SUBJECT: Forwards revised response to draft SER Open Item 136 re loss of component cooling water to reactor coolant pumps. Flow diagram re component cooling water sys also encl.

SHEARON HARRIS NUCLEAR POWER PLANT  
UNIT NO. 1 - DOCKET NO. 50-400  
LOSS OF COMPONENT COOLING WATER

Shearon Harris Nuclear Power Plant  
Draft SER Open Item 136 (410.13)  
Revised Response

FIGURE 9.2.2-3

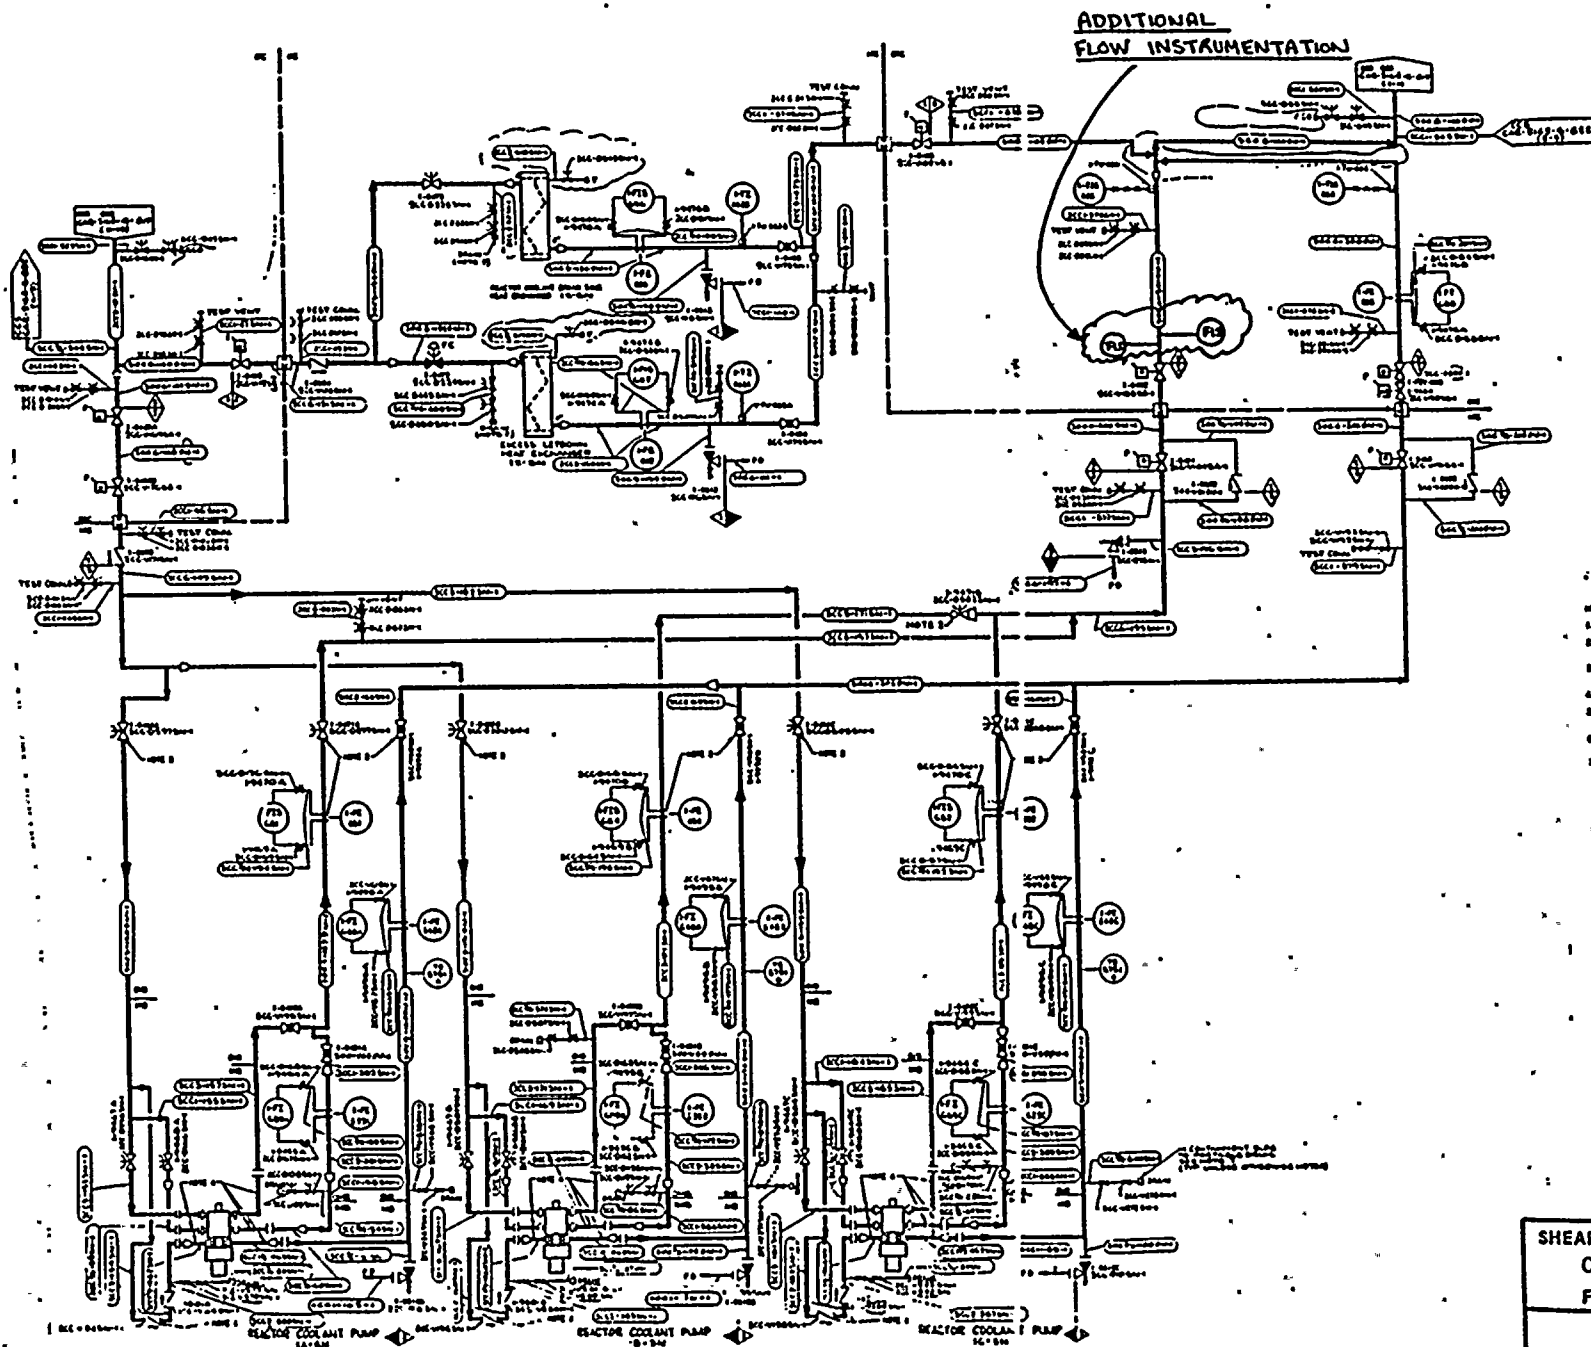
Figure 9.2.2-3 indicates that a single active failure (e.g., spurious closure of a containment isolation valves) can result in loss of component cooling water flow to the reactor coolant pumps (RCP). Loss of cooling to the RCPs must not result in unacceptable damage to RCP motor bearings which could result in fuel damage. We require that you demonstrate compliance with one of the following alternatives:

- (1) Demonstrate with test data that the RCPs can withstand a complete loss of cooling water for 20 minutes and that instrumentation, designed in accordance with IEEE 279, that alarms in the control room is provided to detect a loss of cooling water to ensure a period of 20 minutes is available so that the operator would have sufficient time to initiate manual protection of the plant; or
- (2) Provide instrumentation designed in accordance with IEEE 279 to initiate automatic protection of the plant upon loss of cooling water to a pump.

(Operator action is acceptable if it can be demonstrated that the proper operator action can be taken within 10 minutes).

Loss of component cooling water to the oil coolers of the reactor coolant pump motors will be detected by redundant safety grade flow instrumentation, which will be designed in accordance with IEEE 279 (see attached diagram). Low flow alarms will be provided in the control room to alert the operator. Procedures will be provided to initiate manual protection of the affected reactor coolant pump(s) if component cooling water cannot be restored within ten minutes. Additional protective actions will be based on the Technical Specification requirements for operability of Reactor Coolant Loops.

Other alarms/indicators are also available to the operator to alert him of single active failures (e.g., spurious closure of a containment isolation valve) and to determine which pump(s) should be tripped:

- (a) CCW containment isolation valve position indicators.
- (b) CCW flow alarms for each of the RCP motor oil coolers return lines (upper and lower oil cooler common return).
- (c) CCW temperature alarm for the common return lines from all RCP motor oil coolers.
- (d) RCP motor upper thrust shoe, lower thrust shoe and upper guide bearing temperature alarms. (These bearings are served by the upper oil cooler).
- (e) RCP motor lower guide bearing temperature alarm. (This bearing is served by the lower oil cooler).

(f) RCP motor winding temperature alarm.

The component cooling water lines supplying the RCP motor oil coolers are ASME Class 3 and seismic Category I. During normal operation manually operated isolation and throttle valves on these lines do not require adjustment. Therefore to preclude inadvertent operator action, these valves will be locked in the throttled position. Also, RCP motor vibration detectors and alarms are available to the operators if excessive vibration were to occur.

Instantaneous seizure of a RCP motor due to a loss of CCW to the oil coolers is not considered to be a credible event. However, an evaluation of a locked rotor scenario has been completed for Shearon Harris (FSAR 15.3.3), and the radiological consequences are less than the 10 CFR 100 guideline values.
